City of Pearl, MS
Southeast Sanitary Sewer Improvements (Airport Road)
Pickering Firm, Inc. Project 26917.00

DATE: Monday, 15 November 2024

ADDENDUM #1

SEWAGE VALVE AND VAULT

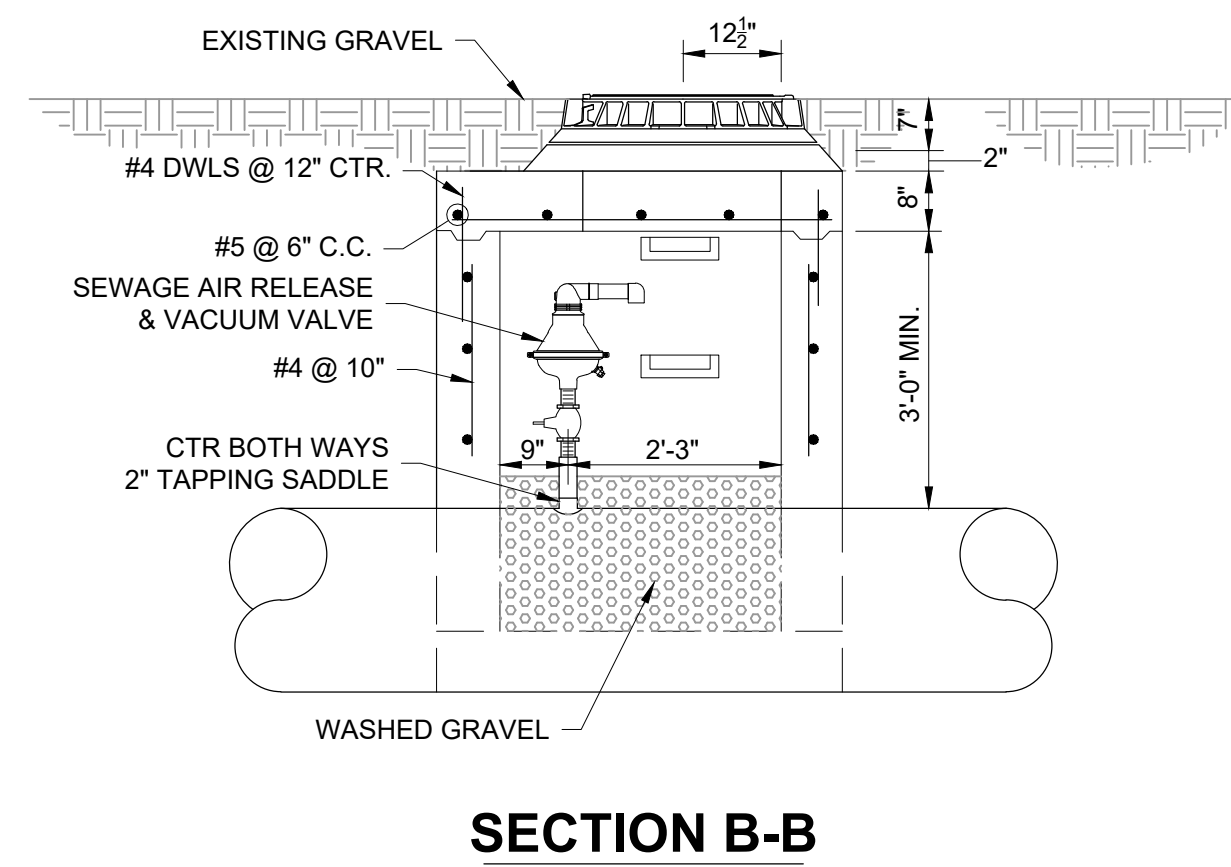
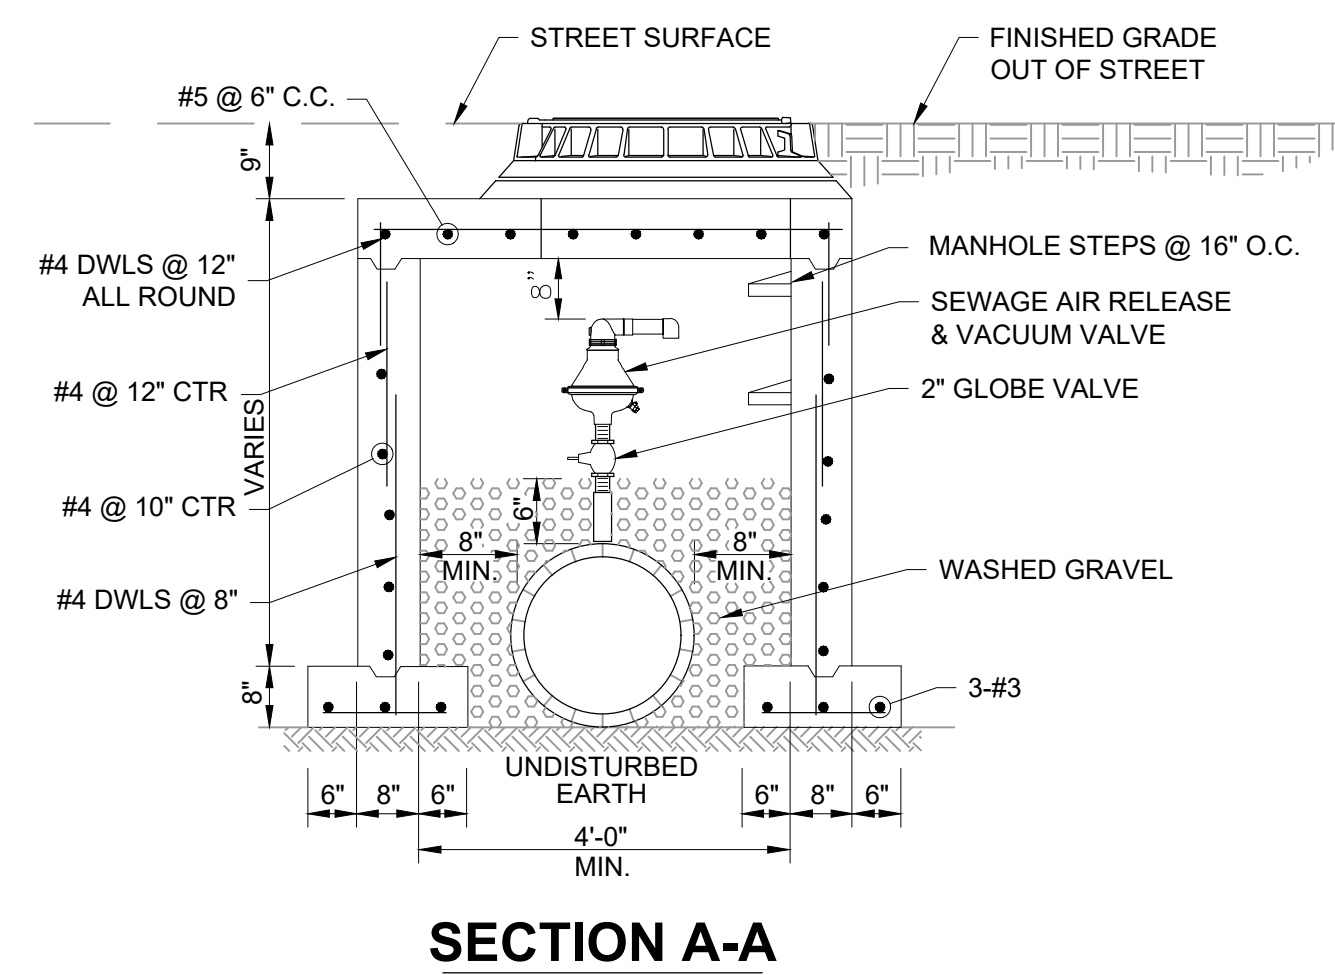
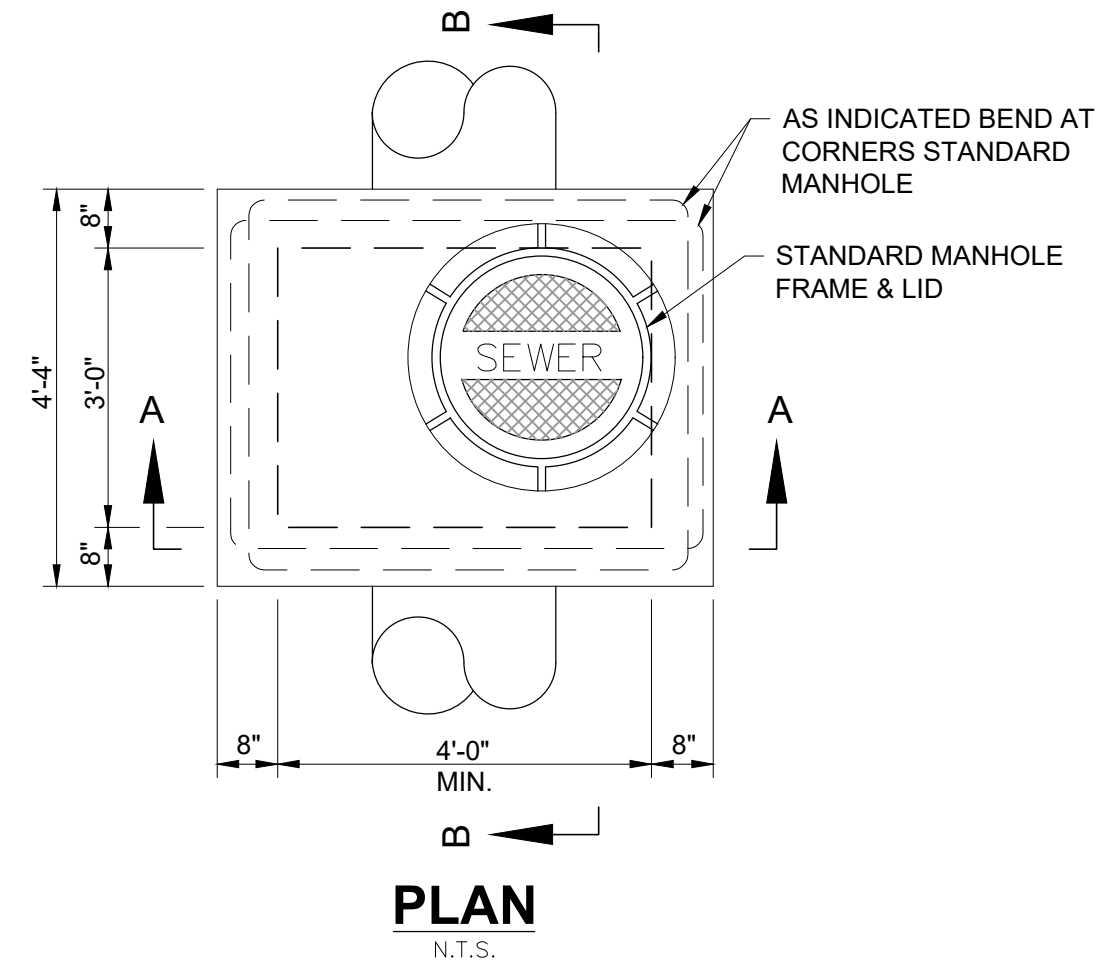
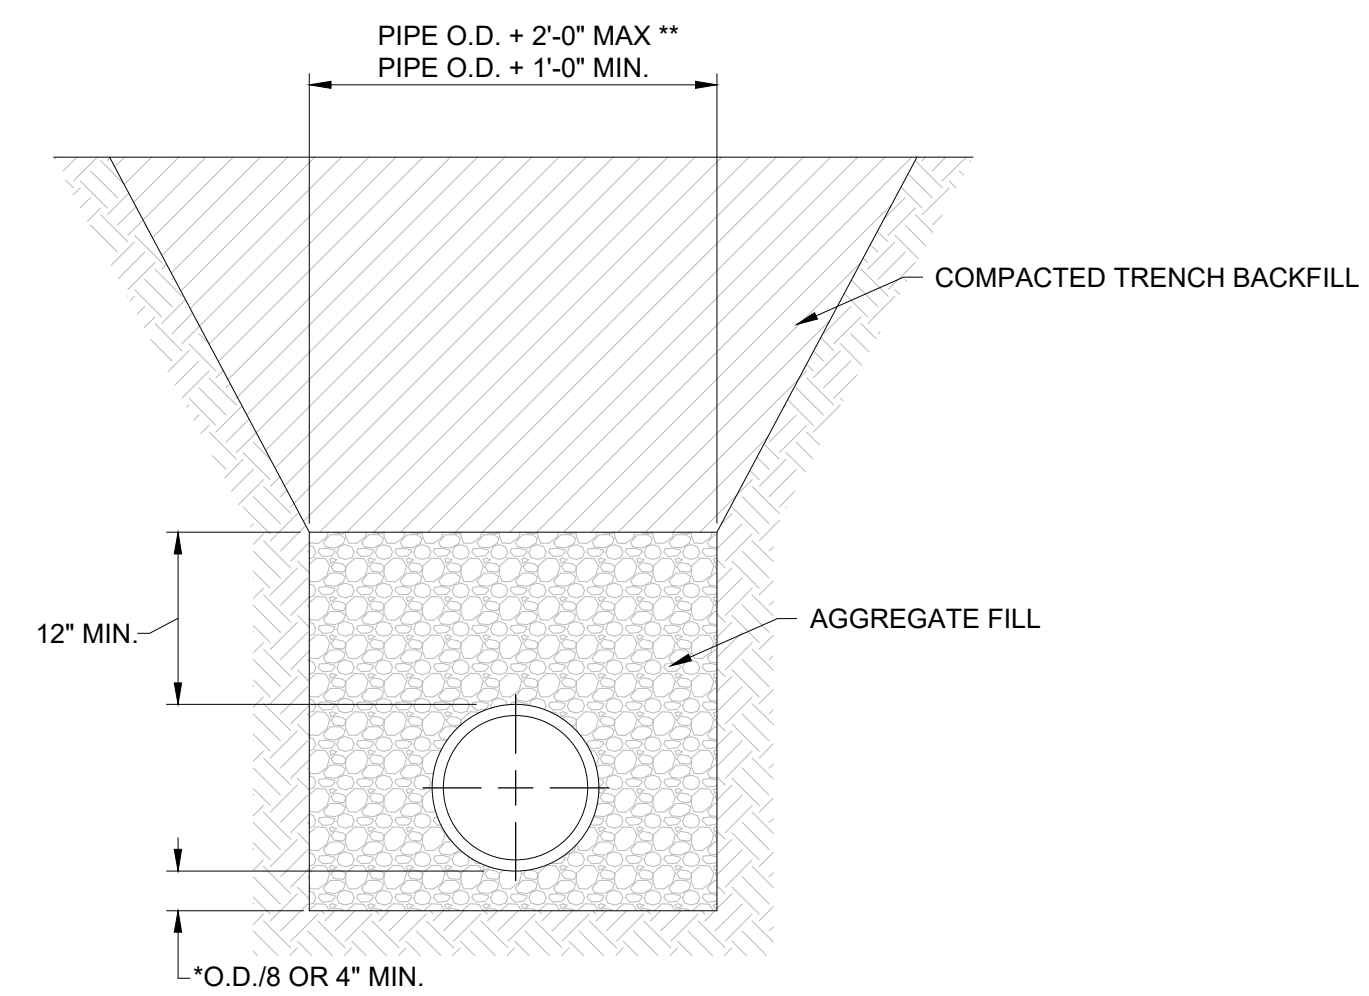
3. Plan Sheet SD1.04, attached.

Removed conflicting air valve housing; added note #3 regarding coating.

Added gravity sewer embedment detail.
